Modification of Development Consent 24/14453 (MOD 4)

We, Hidali Pty. Ltd., refer to the recent email request for additional information (dated 30.10.2024) application for modification of Development Consent No. 10064 (**MOD 4**).

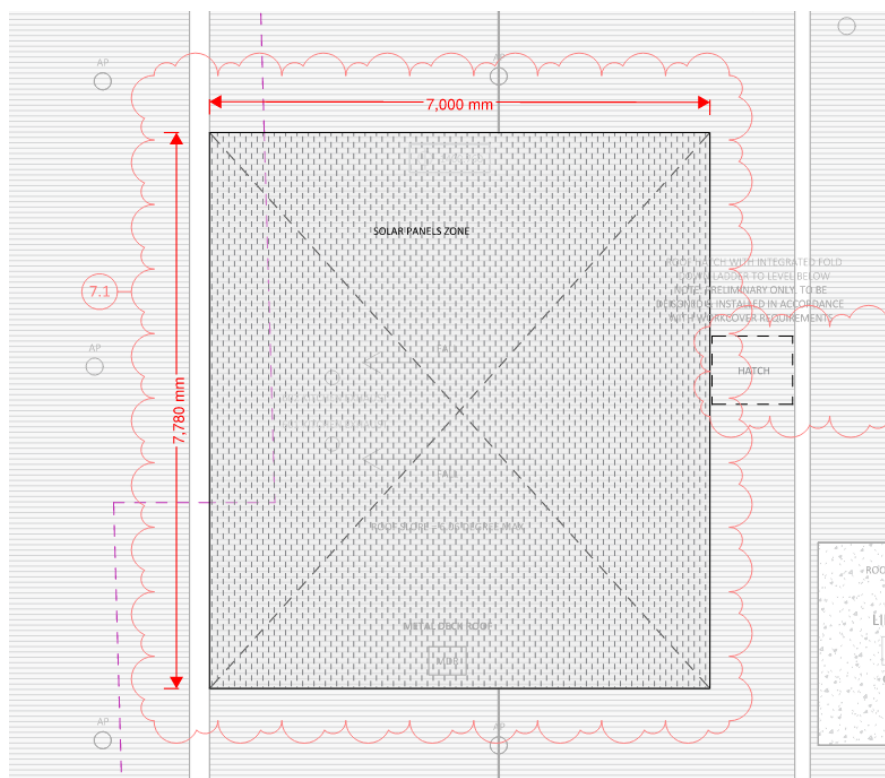
a) of solar panel overall dimensions in plan and section

The overall dimensions in plan will be no larger than the approved pop-up roof, which is 54.5 m² (7.78m east-west by 7m north-south). Please see the snapshot below for reference:

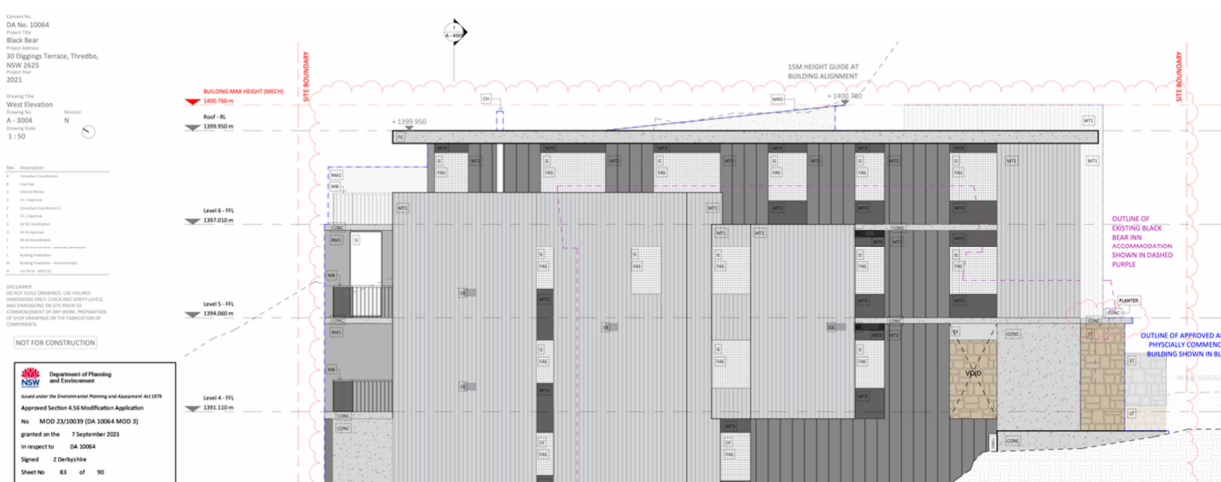
b) of any solar panel mounting or subframe details;

The installation is a slim subframe system and solar panels, laid parallel to the roof sheeting which will be less than 140mm in depth. Reference images from supplier:
